Staff Report

To: BOZAR
From: Jessie Earley, Town Planner III
Meeting Date: BOZAR, March 25, 2025
RE: Liebl (226 Sopris Avenue), Final Review

PROJECT TITLE: Liebl (226 Sopris Avenue)

2/10 DRC and 2/25 BOZAR: Revised Site Plan

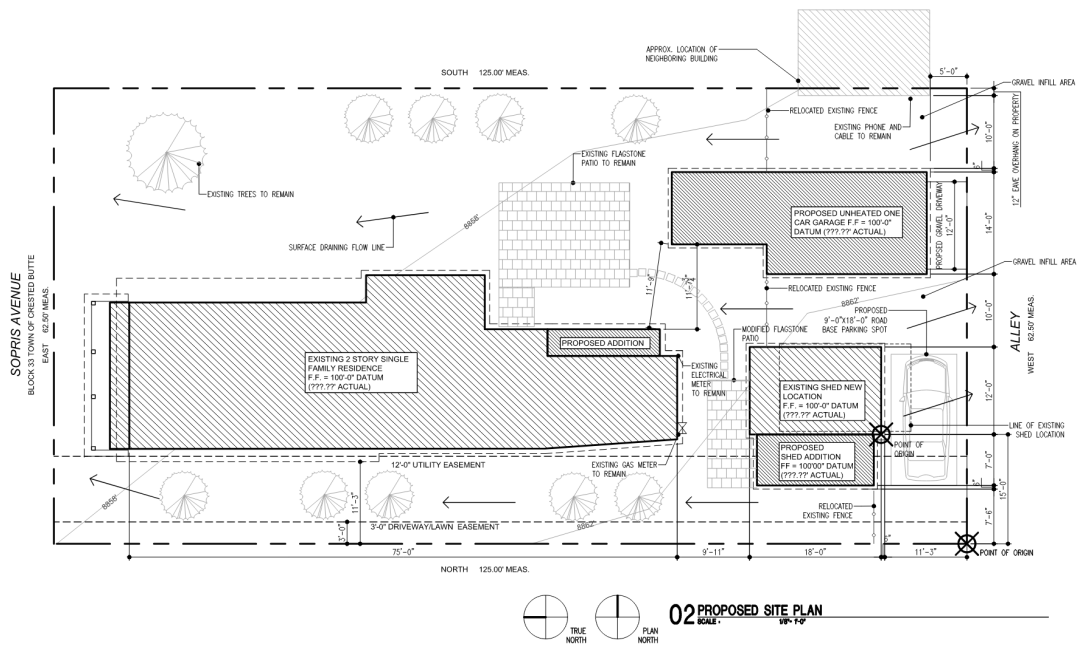
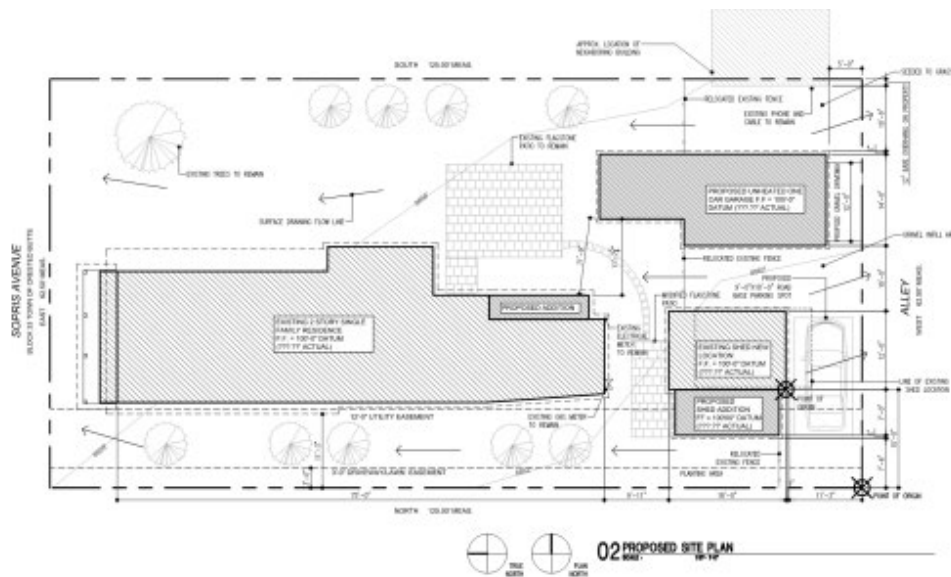
GL	Staff Analysis	DRC Recommendation
Topography	Topography is not included, but should be. This information is not anticipated to impact FAR or height requirement.	Add information to the plans
2.8 Drainage	Drainage arrows have been shown and show drainage to the north and south to the alley.	Add information to the plans which has been provided.
Easements	There area existing easements on the west portion of the lot, which includes a 3' driveway easement and 12' utility easement. There is a letter from the property owner to the east expressing support for the addition.	Support with neighbor support.
2.16 Substantial landscaping	The plan is fairly minimal. Provision of a final landscape plan will be required if there are revisions after permitting.

2.7 Snow Storage	Snow storage has been depicted on the plan and corresponds to the areas to be plowed.	Support
2.27 Fences	An existing fence is on the south. Confirmation is needed if there will be a new fence proposed.

Plan view – Accessory Building – proposed OPTION 1 (1/28/2025 BOZAR)

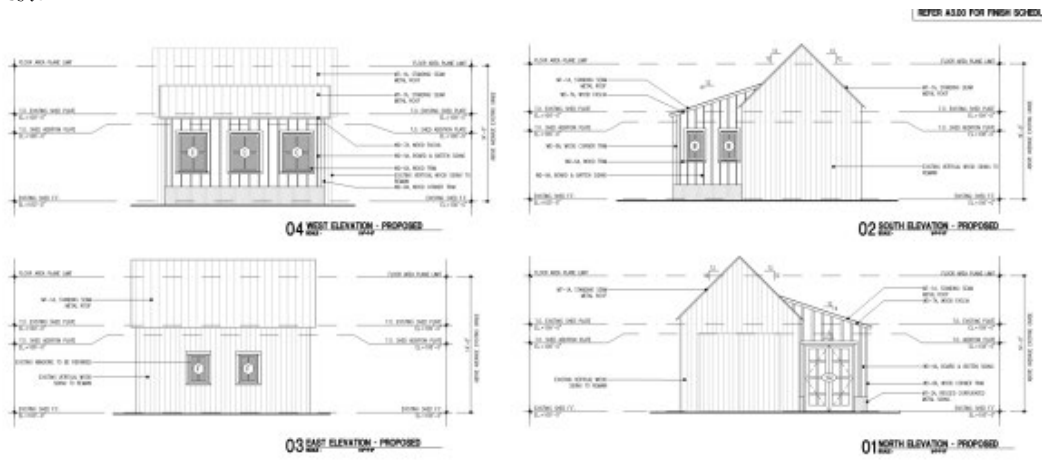
3.18 c Mass	<u>Accessory:</u> The existing AB is 216 sf and the addition is 111 sf, which is smaller in size. Staff feels that the addition does not appear large in comparison with the existing structure and other structures in the surrounding R1C zone district and the proposed plans match scale of the surrounding buildings within the zone.	Support

3.19/ 3.37 Additions as products of their own time	<u>Accessory:</u> The addition to the existing AB is proposed to match. The additions should have siding proposed that should be distinguishable from the existing historic building.	Support 1/21 DRC: Members voiced that a small distinction would be good, but it should not be too different, as the nature of the buildings are simplicity. 2/10 DRC: Members voiced support for the revised materials details.

North – proposed French door (accessory building)

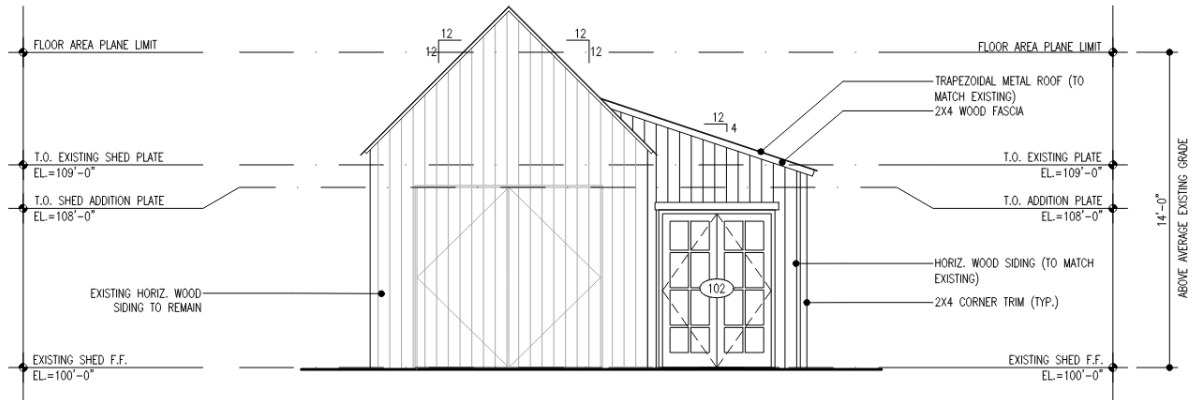
The garage door (carriage style) existing will be rehabilitated (north). **There is a wood French door proposed on the north elevation with divided lights. The door plan states that this door will be aluminum clad (red), confirmation is needed.**

North – revised person door (accessory building) – 3/10/2025 DRC

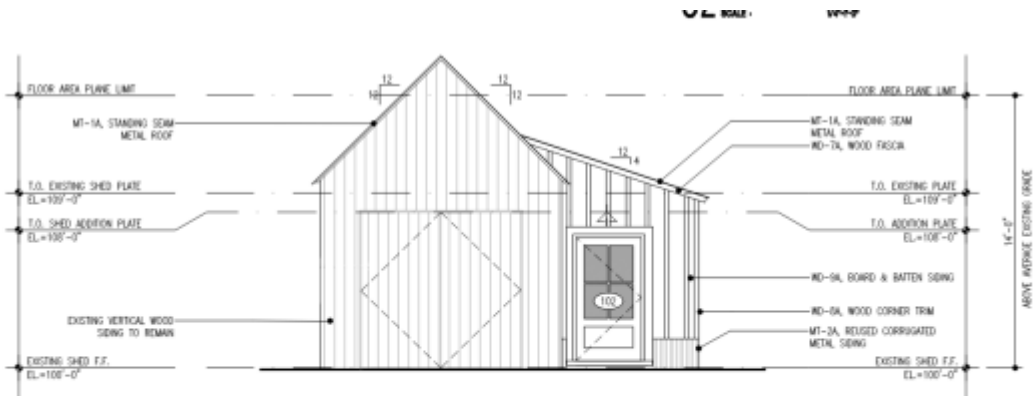
- Fenestration reduced:
- Windows on the west elevation of the addition to the existing historic accessory building have been reduced from four to three.
- The windows on the west elevation of the addition to the existing historic accessory building have been reduced in size to be square windows.
- The three windows on the south elevation of the addition to the existing historic accessory building have been reduced from three windows to one window.
- The French doors, as proposed on the north elevation of the addition to the existing historic accessory building was revised to a single person door.

The addition to the existing accessory building appears subordinate and a connector module wouldn't be needed. It steps in from the north and south and also steps down from the ridge. All historic materials must be kept on the existing historic building. Windows were revised and now meet the intents of the GL with three windows on the west, one on the south and a single door on the north. The new addition proposes materials to vary slightly.
